Pre-Application Report

Case Number / AMANDA No. 22-102664-PA / PRE-AP22-09

Project Description	Pre-application conference to discuss a proposed Class 1 Design Review, Class 3 Site Plan Review, Class 2 Adjustments, and Class 2 Driveway Approach Permit for a 94 unit apartment complex on 3.25 acre Parcel 2 of Partition Plat No. 2021-64 within a 3.54 acre territory that is being annexed with a Multi-Family Salem Area Comprehensive Plan Designation and RM2 (Multiple Family Residential 2) zoning.
Property Address	3476/3480 Blossom Drive NE 97305 (Attachment A)
Assessor's Map and Tax Lot Number	Marion County Assessor Map and Tax Lot 073W01A03300
Existing Use	Single family dwelling and accessory structures
Legal Units of Land	The parcels were created through a Marion County partition process – Partition Plat No. 2021-64.
Comprehensive Plan Map Designation	MFR - Multi-Family Residential
Urban Service Area	The subject property is located outside of the City's Urban Service Area.

A100

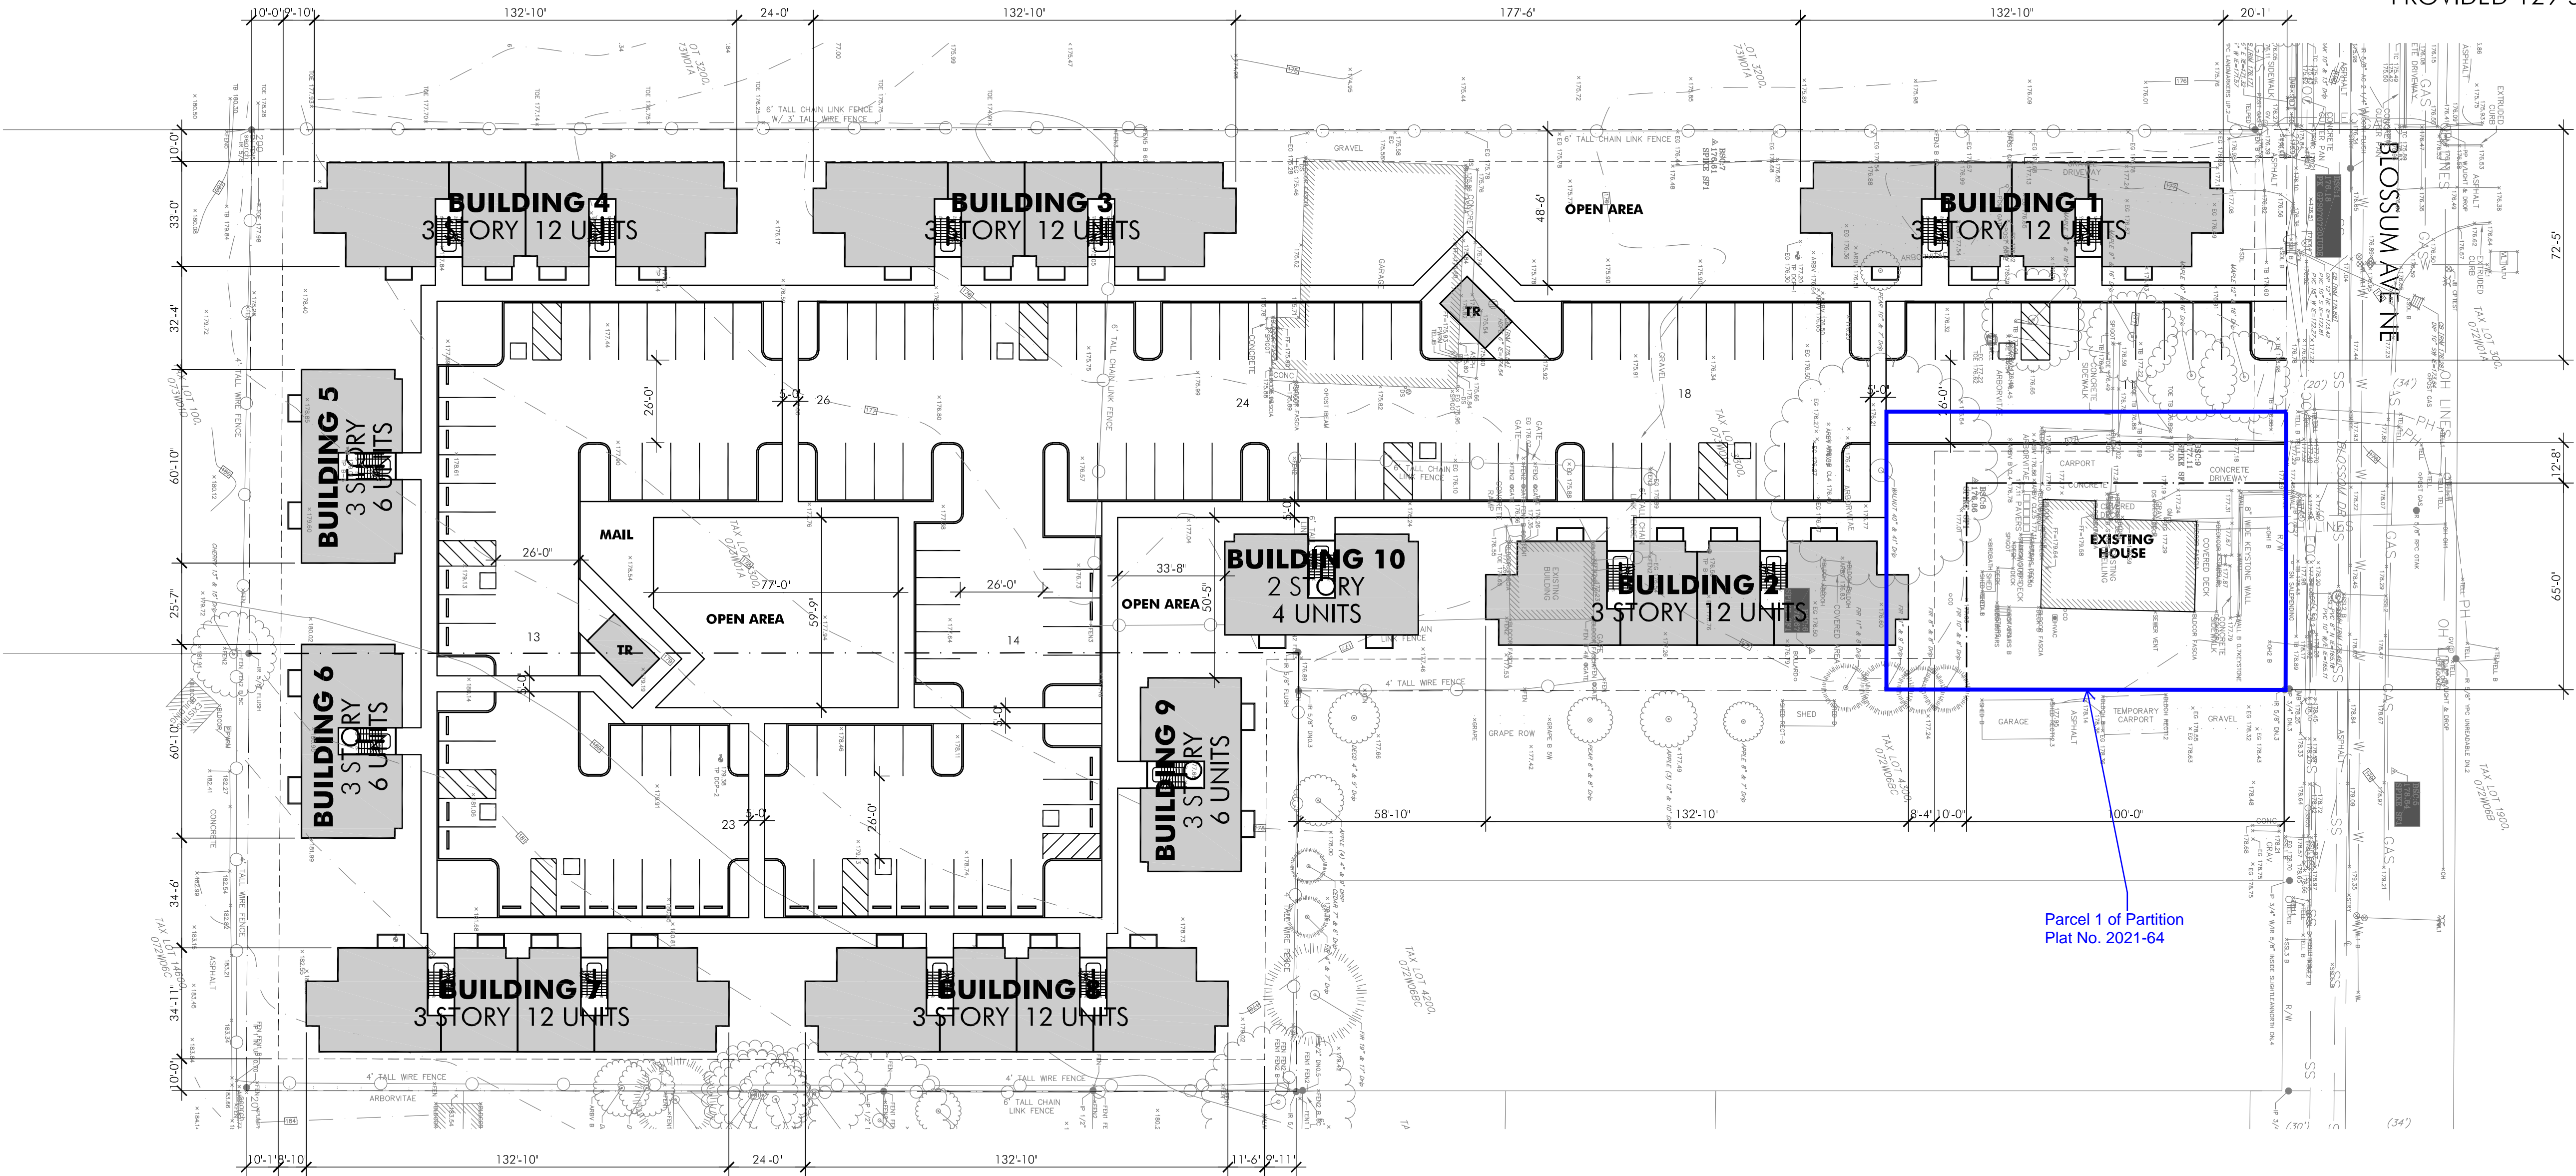
The site plan must be significantly redesigned to reflect the partition parcel boundaries and applicable setbacks. A minimum 24-foot-wide drive aisle would be required in the narrow part of the property near Blossom Drive NE. The remaining area available between setbacks would be approximately 39 feet wide. The proposed building, parking, and other required elements will not fit within the 39-foot-wide area. I would recommend constructing an office and/or recreation building near the street, parking spaces behind it, then an open space / recreation area, a solid waste service area, etc. The corrections will also affect Building 2 and parking/vehicle use areas.

Lot depth to width maximum is 300%. Proposed depth to width, due to irregular lot shape, is 318%. An adjustment will be required to exceed the maximum of 300% allowed for a multi-family use.

Setbacks must be revised to meet standards from accurate parcel boundary and other boundaries.

Staff response: For 94 units, the minimum area is $1000 + 250 (74/20) = 1000 + 250 (4) = 2,000$. The proposal meets the standard. When the site plan is reconfigured, please ensure that it meets the standard. Please submit plans indicating that all private open space meets the dimensional standards in Table 702-4 and the standards of 702.020(a)(1)(D).

Staff response: No landscape plans were submitted. When the site plan is reconfigured, please submit preliminary landscape plans that demonstrate compliance with these standards. A minimum 71 trees are required for the 3.25-acre parcel.

Staff response: Please place landscaped planter bays in a more regular arrangement islands directly across the aisle from each other, wherever possible, to meet (1). The proposal does not meet standard (2) because it includes parking that is closer to Blossom Drive NE than the building. For (3), please add more connections across the long north-south drive aisle for access between buildings and to the trash area. When the site plan is reconfigured, please demonstrate compliance with the standards.

SHEET:
A2.03A
BLDG A - ELEVATIONS

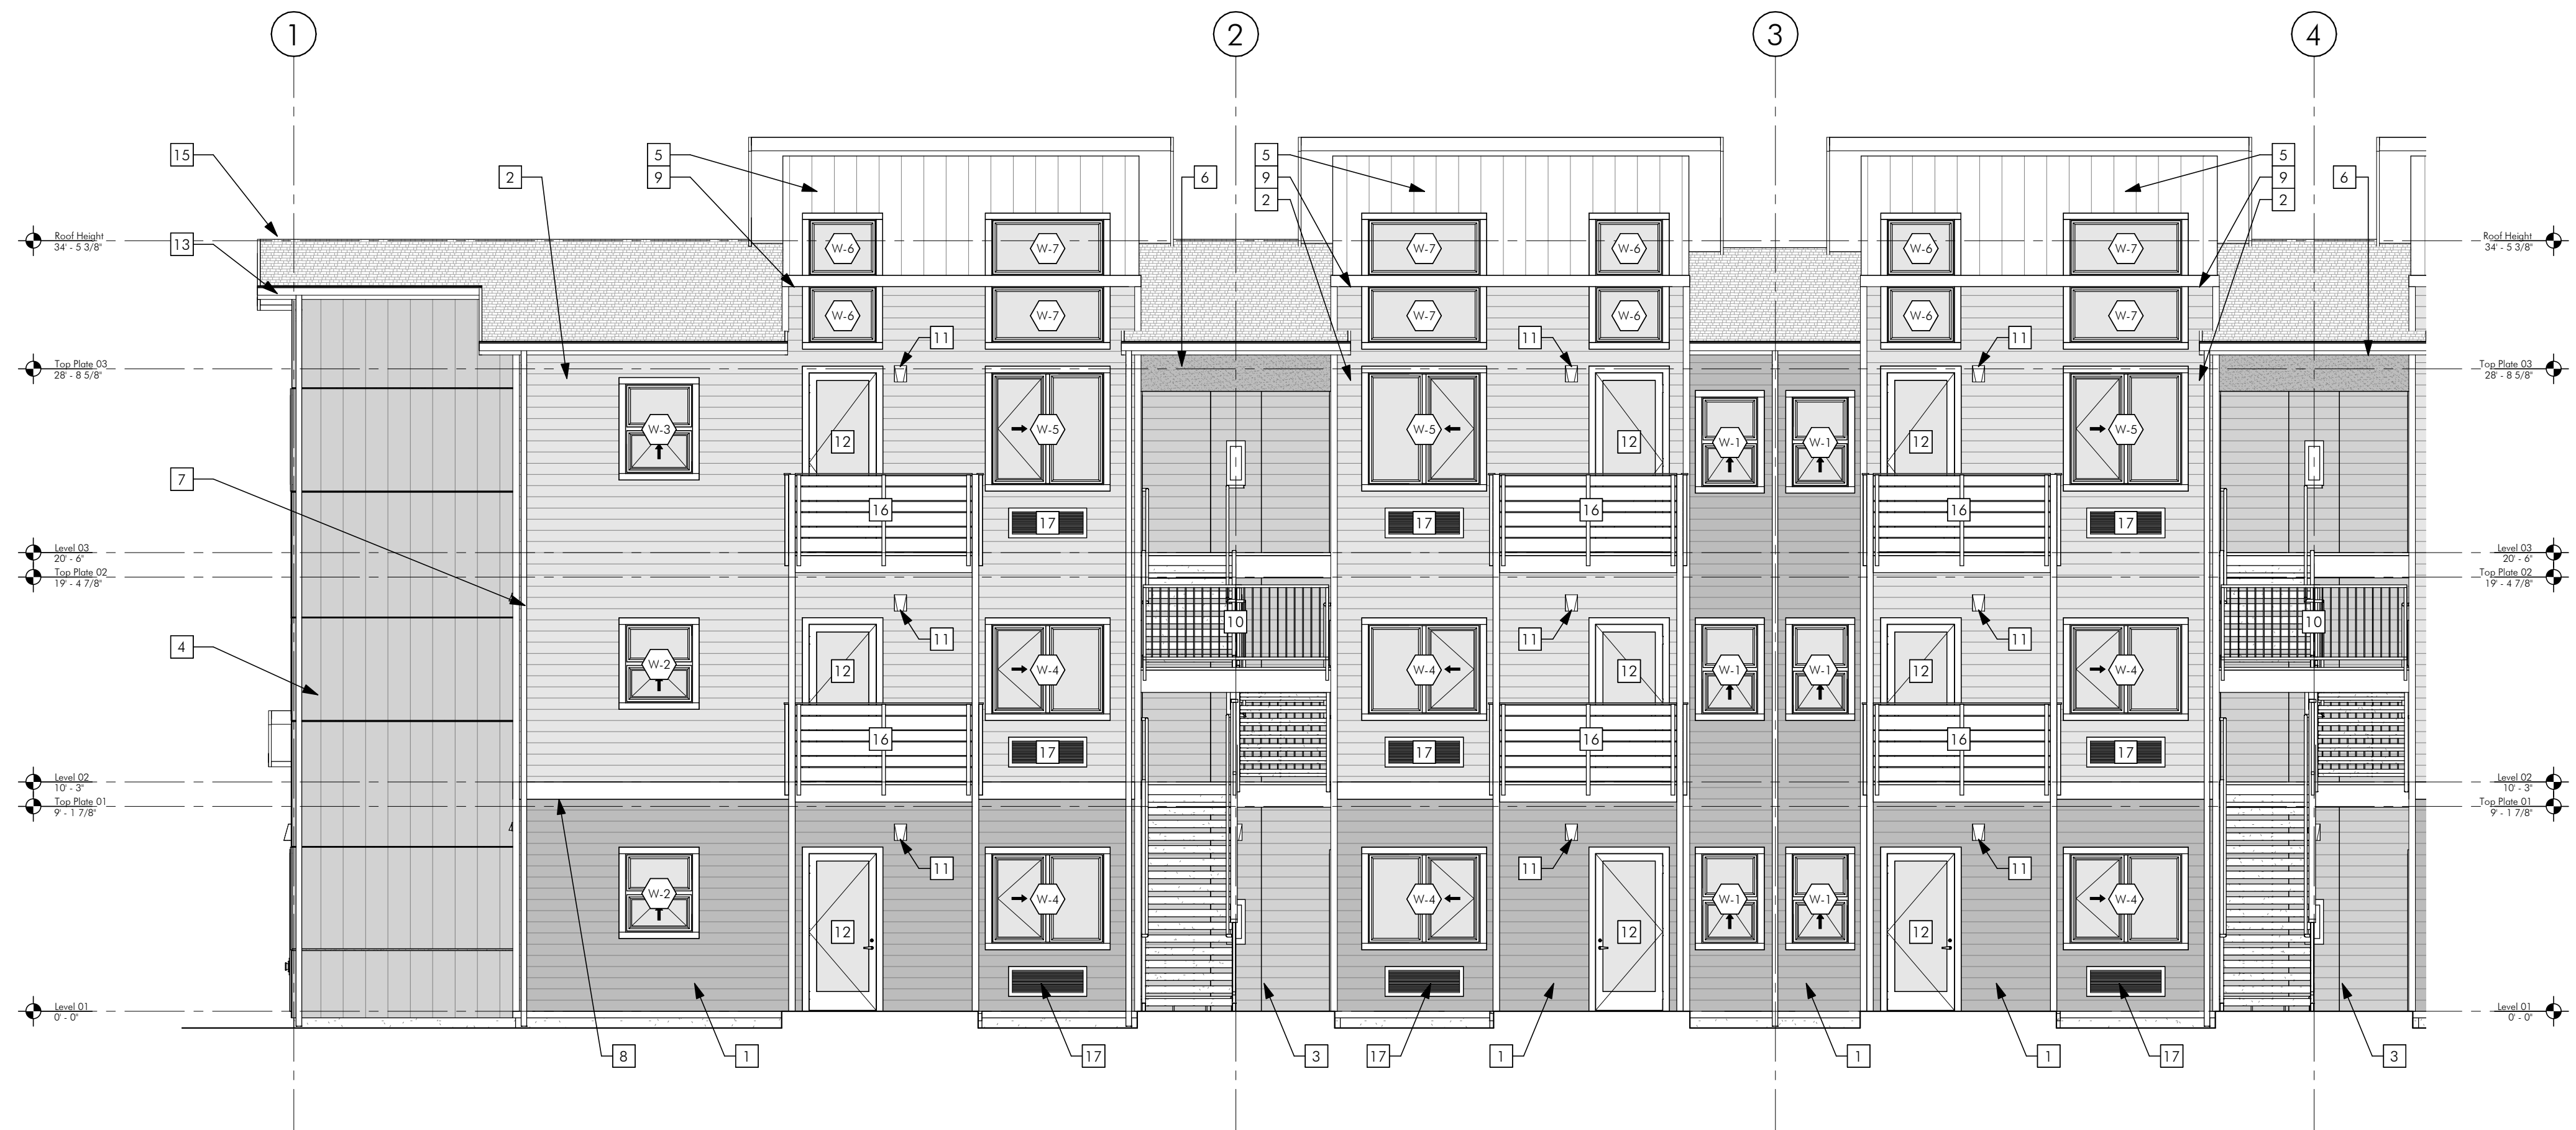
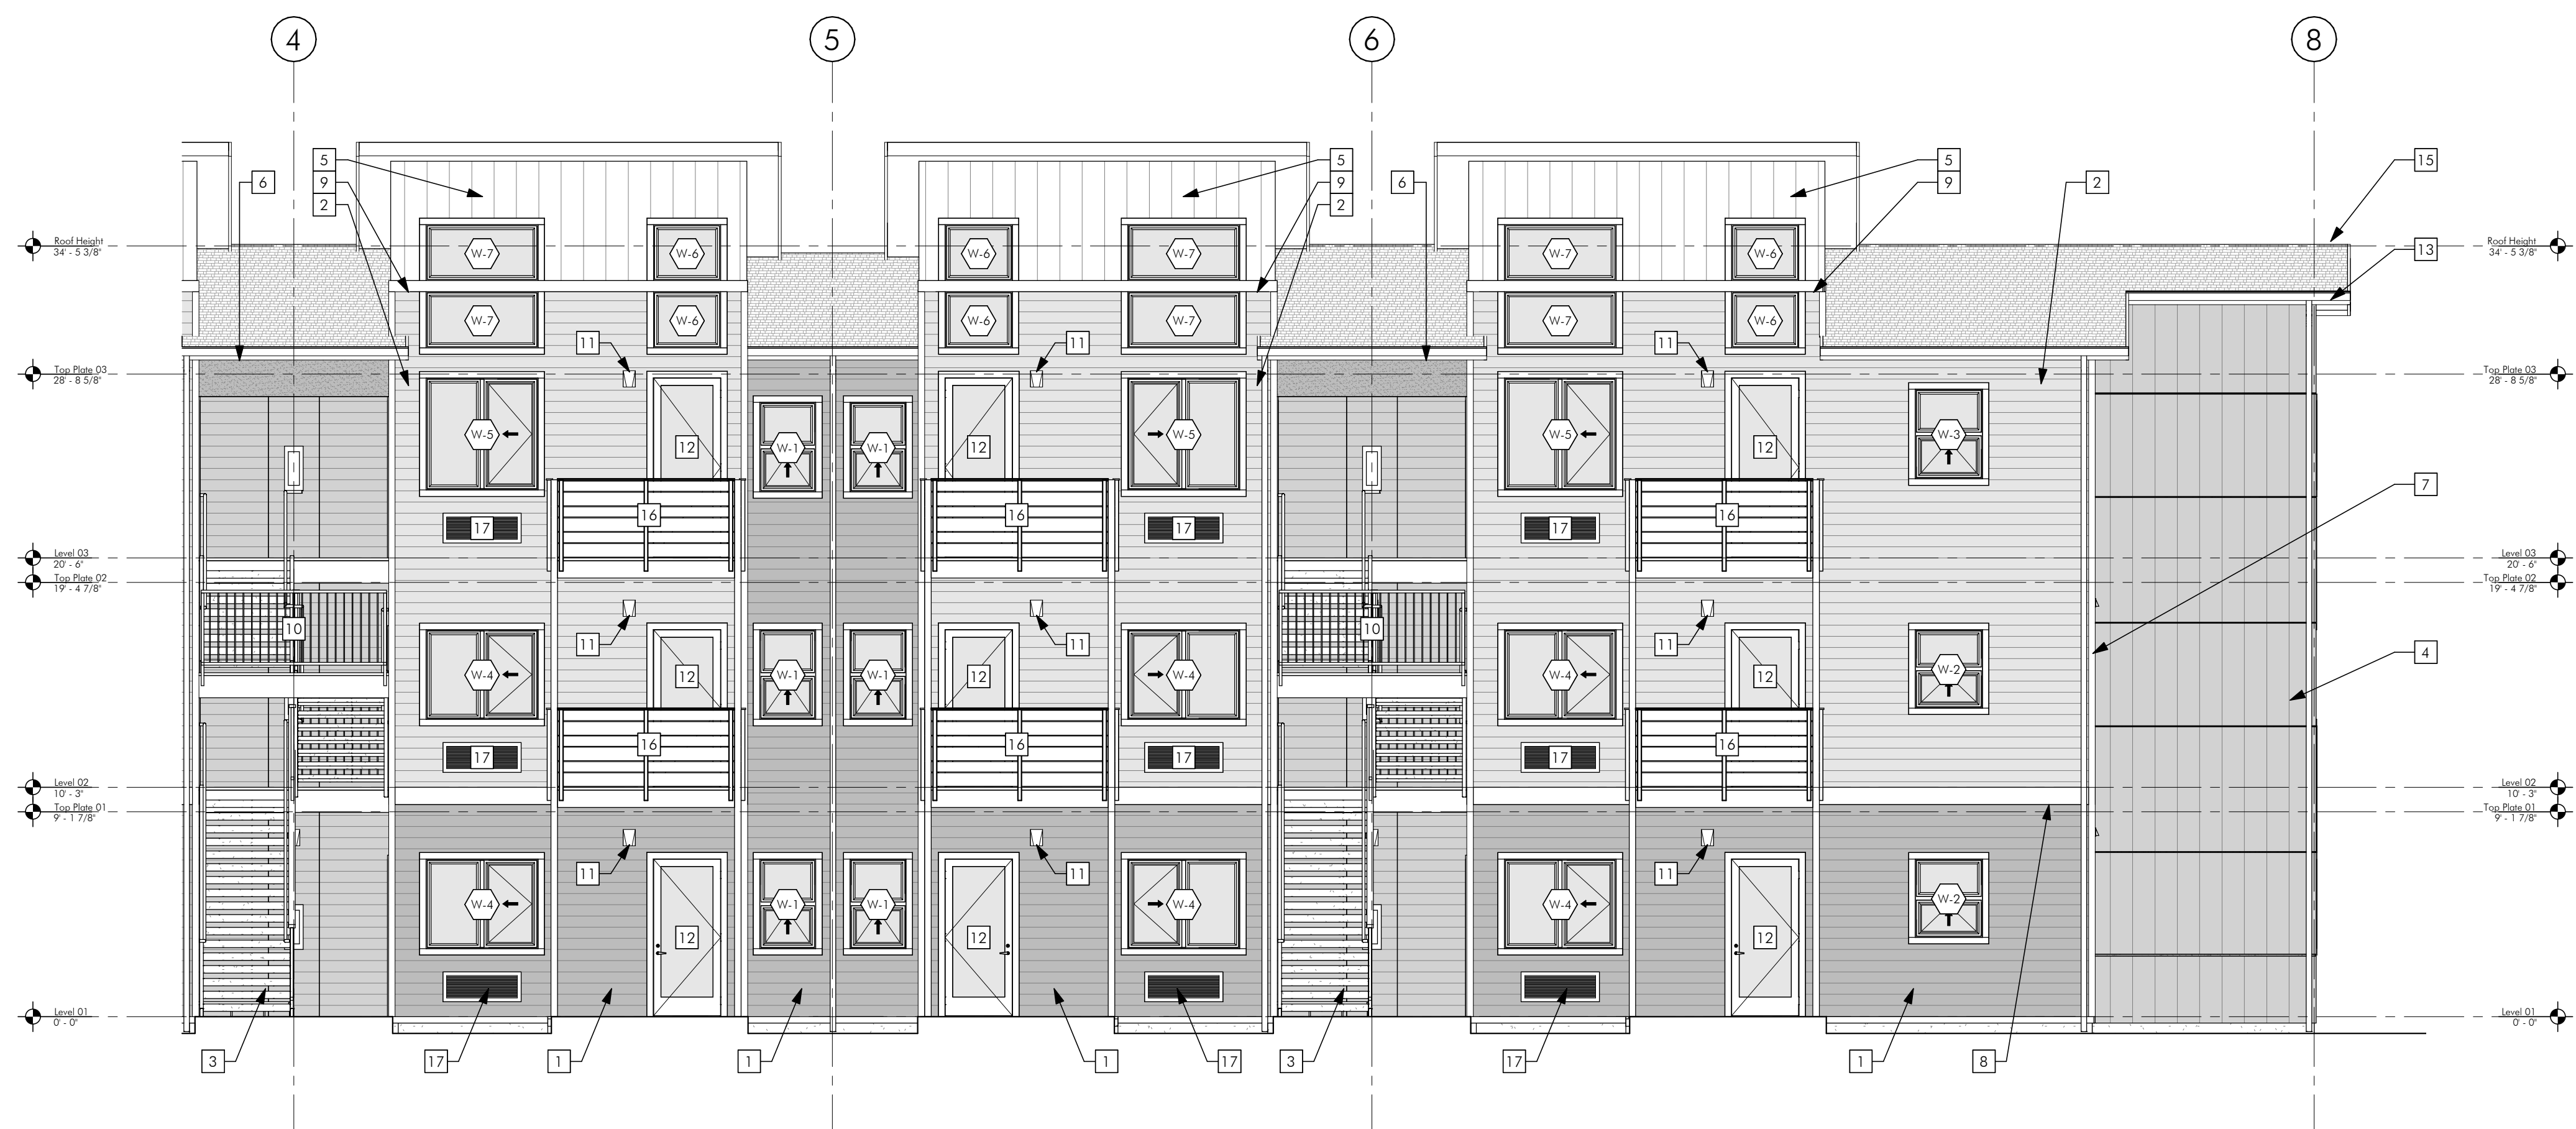
Staff response: *Standard 5 applies to any building located near the street, not only to the buildings with apartments. Staff cannot determine whether the outward-facing elevations meet standard 9, which applies to all vertical faces 80 feet or longer, because these faces are shown on the site plan as continuous lines exceeding 125 feet in length. When the site plan is reconfigured and the elevation drawings are submitted, please demonstrate compliance with the standards.*
